Memorandum - Amended Draft Remedial Investigation Work Plan

July 11, 2006 – 1:30 p.m. Star Lake Canal Conference Call Summary and Documentation of Discussion

RESPONSE TO THE REVISED REMEDIAL INVESTIGATION WORK PLAN REVIEW COMMENTS
STAR LAKE CANAL SUPERFUND SITE, JEFFERSON COUNTY, TEXAS
July 12, 2006

FIGURE 7-1
Remedial Investigation Schedule (Revised 7-12-06)
Star Lake Canal Superfund Site
Jefferson County, Texas

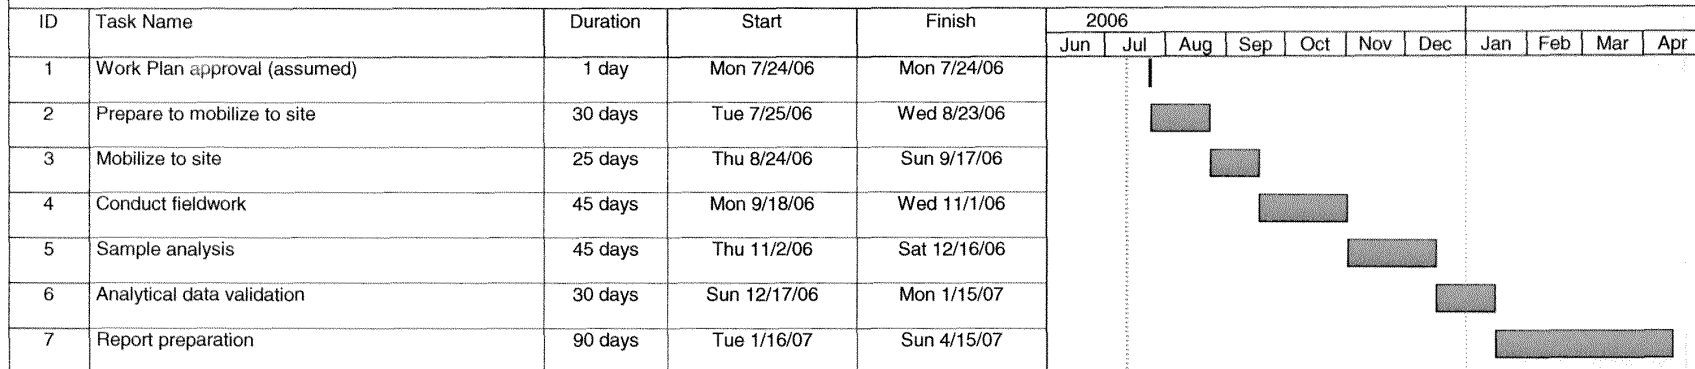
Note: The mobilization time in Task 3 was decreased by 5 days from the previous schedule submitted on 6-8-06.

FIGURE 6-4 (REVISED)

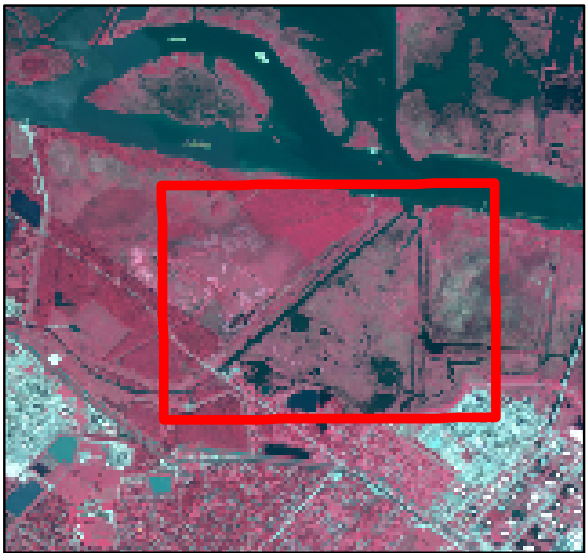
Jessica White then addressed the second issue (comments 1a-b and 3) which focused on the need for additional sampling locations to investigate areas where no samples had been proposed. She agreed with the proposed seven additional sampling locations shown on the three maps, but thought that the Molasses Bayou area needed still more sampling

locations. The specific concern was that Hurricane Rita might have redistributed sediments outside of the main canals and bayou. A random sampling design was discussed as a methodology to add a couple of additional sampling locations, however, it was decided that biased sampling would probably better address this issue. Three additional sampling locations in the Molasses Bayou area were then selected and agreed to by the conference call participants. All of the proposed sampling locations, including the ten added locations, are shown in attached Figures 6-2, 6-3 and 6-4.

Item No.	Reference	Comment made by	Comment	Response
3	General	White, National Oceanic and Atmospheric Administration	While it is understood that additional sampling beyond what is proposed in the current Work Plan is likely, the sampling described in the Work Plan should be expanded to be more comprehensive in scope. The trustees noted in previous comments that some areas were not covered at all, and that it was not clear how the sample size and distribution was decided. One of the concerns is that certain areas within the "potential area of concern" are not being sampled at all (see previous comments on Molasses Bayou especially the southeast corner, wetlands adjacent to the canal, and the confluence with Neches River". There are several portions of the site not represented by even a single sample of any media. If an area is never sampled in Tier 1, why would Tier 2 sampling occur in that area if there will be no Tier 1 samples to indicate levels at ecological risk? To be efficient, the initial sampling effort should utilize the available sample data (from the SSI, ESI) to determine the locations for sampling (based upon past distribution) and number of samples (based upon variability of contaminant concentrations in media).	The sample locations were selected based on a source and path rational as described in the Work Plan. There is no reason to suspect that constituents would be located in the southeast portion of Molasses Bayou because there is no known source and no pathway. Nevertheless, two additional samples will be proposed in Jefferson Canal, two additional samples will be proposed in Star Lake Canal, and three additional samples will be proposed in the vicinity of Molasses Bayou to further expand the sample collection locations. Based on the July 11, 2006 conference call three additional sampling locations were added to the Molasses Bayou area so that the total sampling locations added to that area will be six.

FIGURE 6-3 (REVISED)

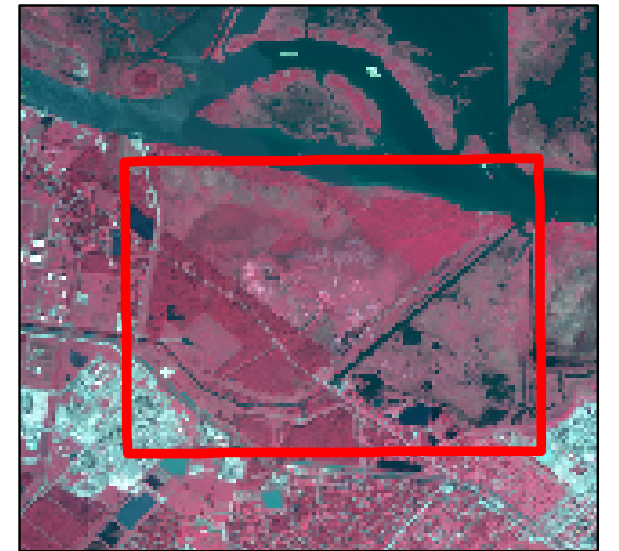
<i>Item No.</i>	<i>Reference</i>	<i>Comment made by</i>	<i>Comment</i>	<i>Response</i>
GENERAL COMMENTS				
1a	General	Ash & Tischler, US Fish & Wildlife Service	While the revised draft does state that additional sampling will be performed in Tier 2 if the presence of COCs posing ecological risk is found at locations from Tier 1, this does not entirely address our concern regarding adequacy of the Tier 1 sampling. One of our concerns is that certain areas within the "potential area of concern" are not being sampled at all (see our previous comments on Molasses Bayou especially the southeast corner, wetlands adjacent to the canal, and the confluence with Neches River). There are several portions of the site not represented by even a single sample of any media. If an area is never sampled in Tier 1, why would Tier 2 sampling occur in that area if there will be no Tier 1 samples to indicate levels at ecological risk? We feel more samples are needed in this area since the revised draft failed to provide justification or clarification of the current sampling plan. For example, we requested a minimum of 2 samples be added to the Molasses Bayou area to increase coverage. Instead the revised draft shows one sample was moved from one location to another, and none were added.	The sample locations were selected based on a source and path rational as described in the Work Plan. There is no reason to suspect that constituents would be located in the southeast portion of Molasses Bayou because there is no known source and no pathway. Sediment transport and deposition resulting from flood stage sheet flow are not believed to be a major pathway. Meteorological and streamflow data pertinent to the site were compiled and reviewed. The frequency of severe precipitation and flood events is extremely low. As shown on Exhibit 1 of the Revised Work Plan, the water elevations measured at the Rainbow Bridge gaging station are not those that would result in overland flow in Molasses Bayou. During periods of overland flow, constituent concentrations in sediment would be reduced due to the amount of additional sediment input from outside the source area into the sediment budget. Nevertheless, two additional samples will be proposed in Jefferson Canal, two additional samples will be located in Star Lake Canal, and three additional samples will be proposed in the vicinity of Molasses Bayou.
